SCS-104 Line Card

November 2011

Hardware Update

Effective November 11, 2011, all SCS-104 Line Cards are being manufactured and shipped with Level C hardware.

Hardware
Level

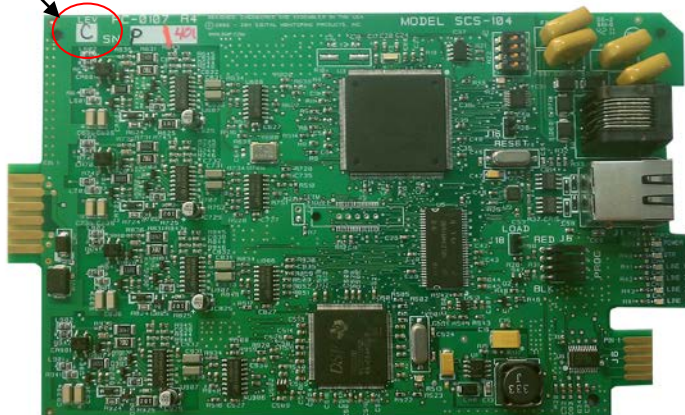
The SCS-104 telephone circuit hardware has been updated to allow the line card to consistently decode the caller ID information such as the Automatic Number Identification (ANI) and Dialed Number Identification Service (DNIS). The ANI is the phone number that the panel called from and DNIS is the phone number that the panel dialed.

Previously on occasion, the SCS-104 could incorrectly decode the ANI/DNIS information producing the wrong phone numbers.

To update to level C hardware, return the SCS-104 to DMP and simply indicate "Update to Latest Hardware Level" on the 5-digit RMA tag. The update will be done as a Warranty Repair at no charge, regardless of when the SCS-104 was purchased. If a SCS-104 is returned for other repair needs, this update will be automatically performed as standard repair procedure. If you need RMA tags, contact DMP Customer Service at 1-800-641-4282.
